RE:- WWDL FOR BALLINCOLLIG REF NO.D0049-01.

Response to Notice in accordance with Regulation 18(3) (b) of the Waste Water Discharge (Authorisation) Regulations 2007 – dated 04 April 2008

LOCATION OF SECONDARY DISCHARGE POINT(S) (SHEET 2 OF 3)

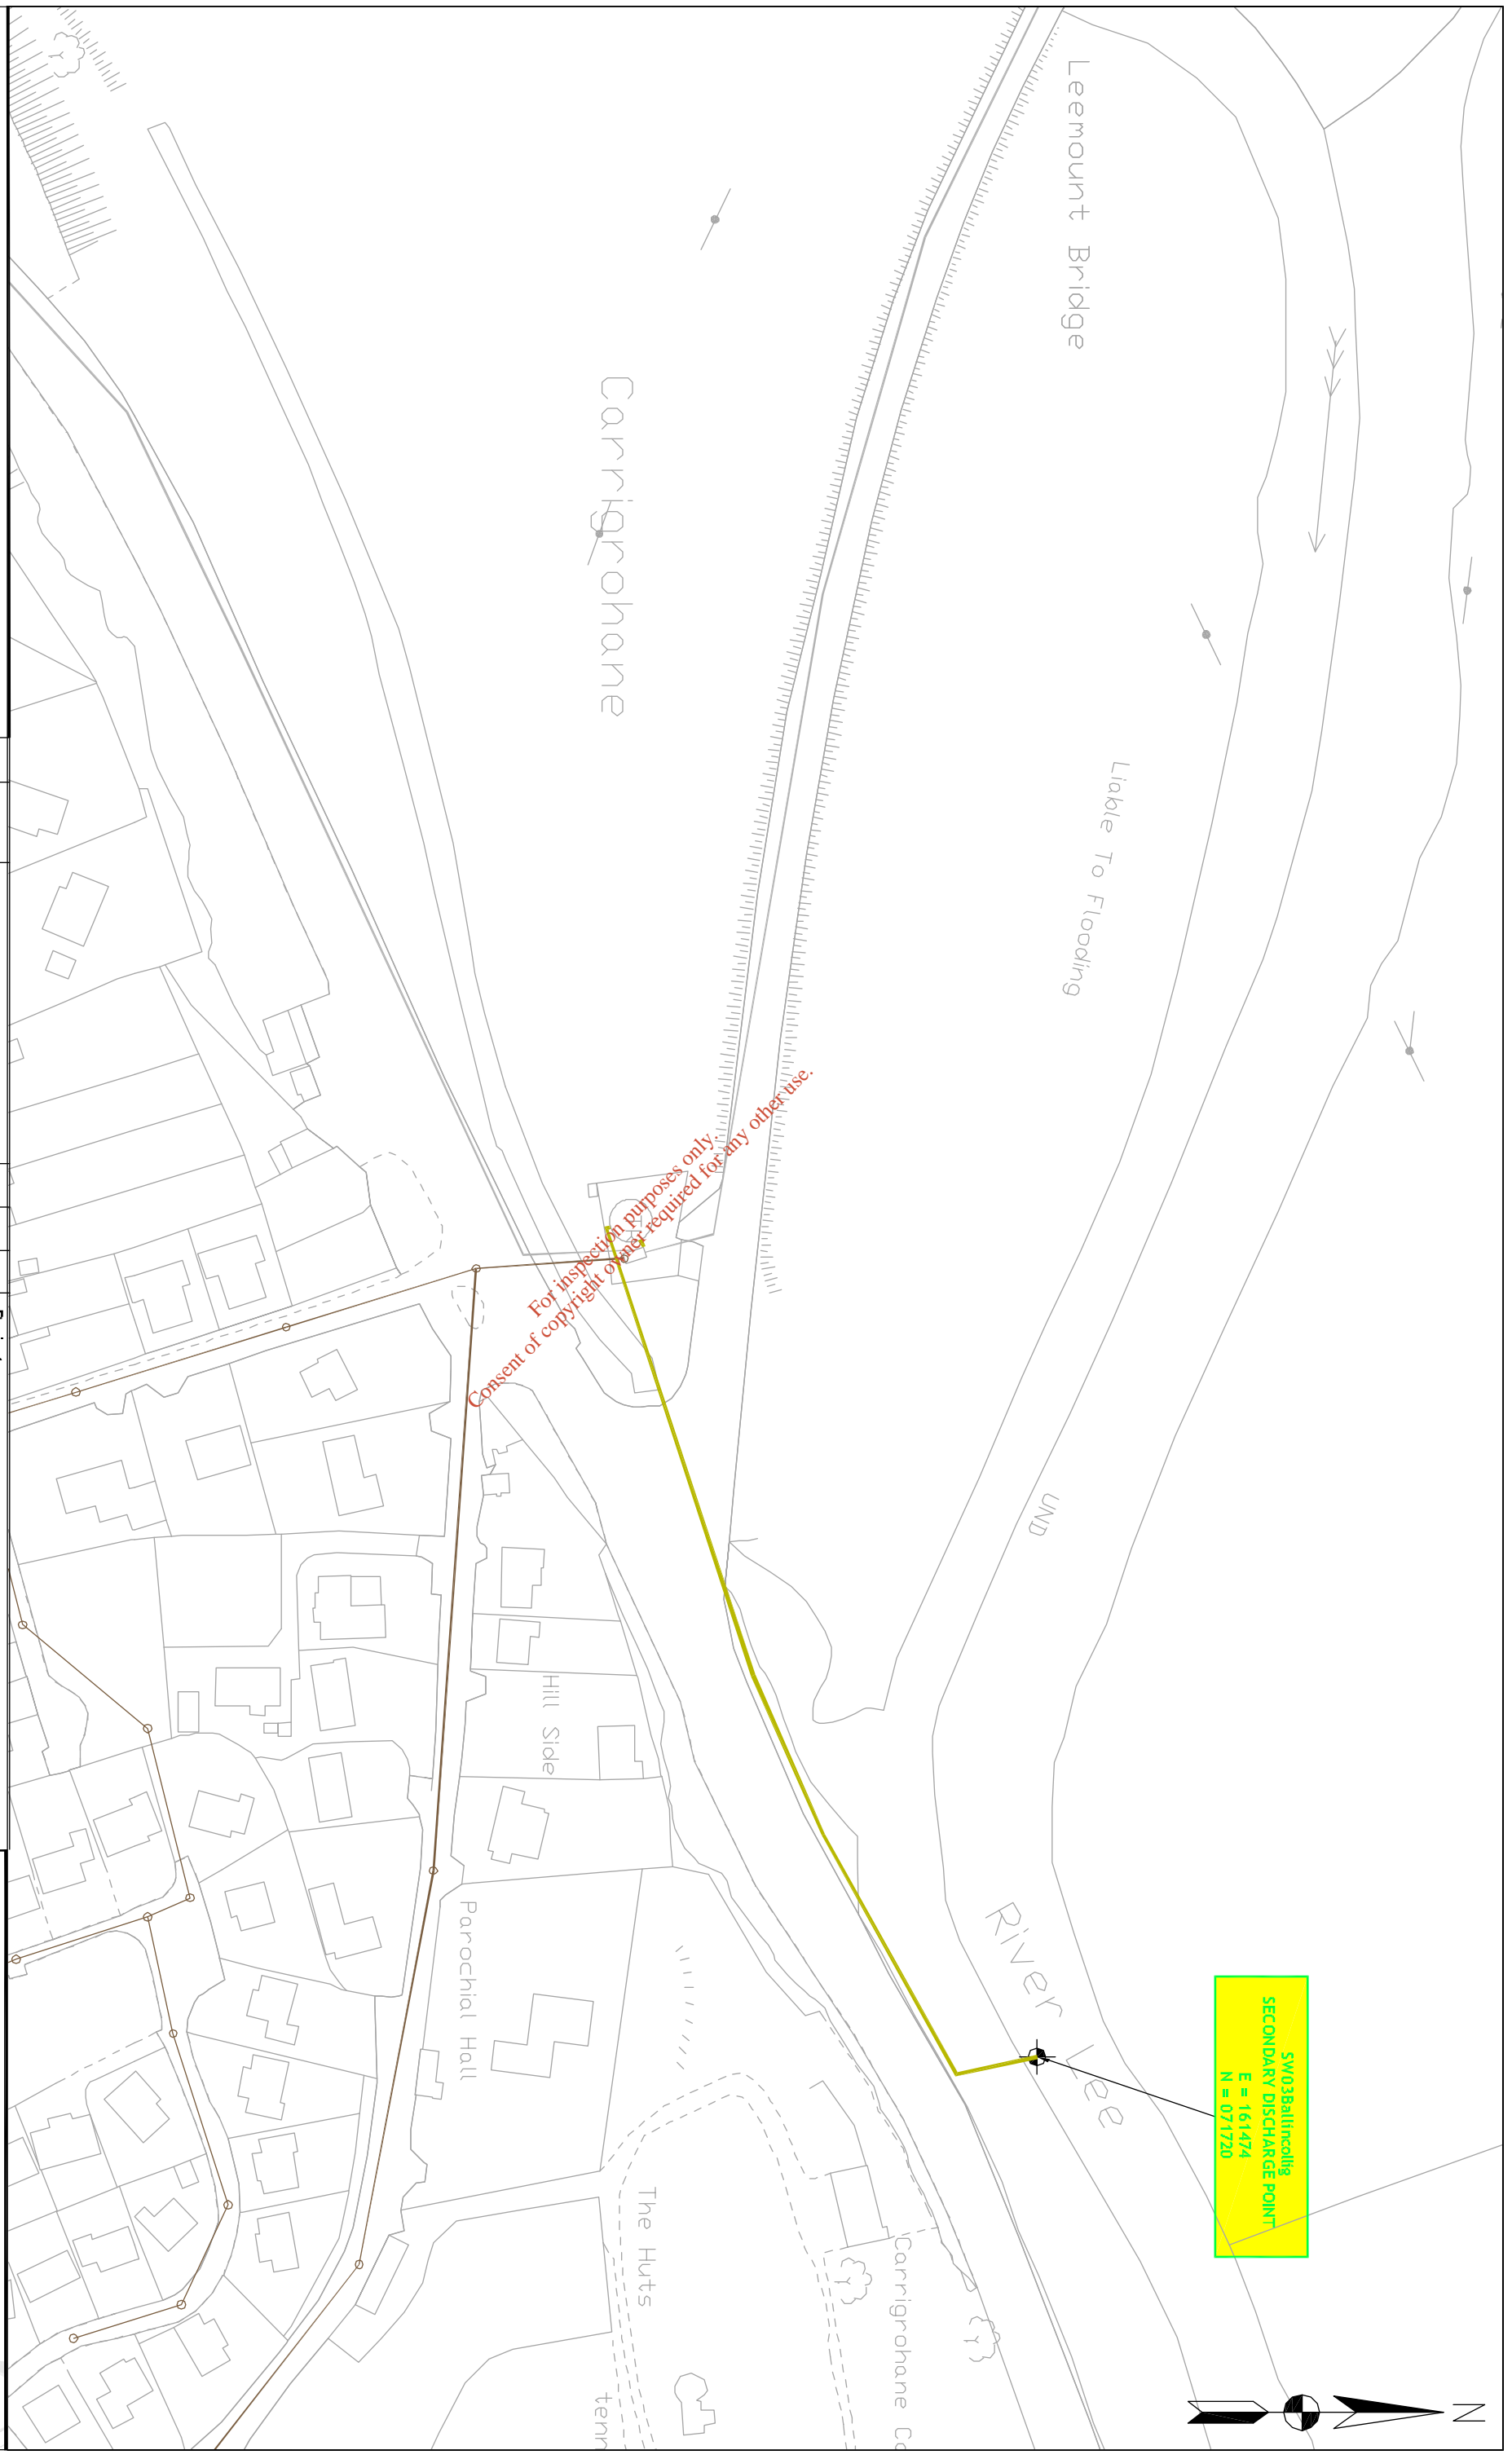
4. *Clarify the location and reference of the storm water discharge points referred to as SW03 and SW05. Give details as required by the application of the discharge referenced SW05.*

The map that was submitted was done so in error. The consultant prepared the original map with the understanding that SW05 was the emergency outfall. There is no outfall at the location of SW05.

Originally the storm holding tank was a wastewater treatment plant with the outfall shown in the originally submitted application as SW03, the outfall was extended during the construction of a bridge. The actual end of the outfall pipe has not been established at this point of time. The pipe discharges into a channel before discharging to the River Lee. The outfall pipe is now an emergency outfall and should only operate in very rare extreme circumstances. A revised map is attached, which shows where the emergency overflow would eventually enter the River Lee and this is now shown as SW03 on the resubmitted maps.
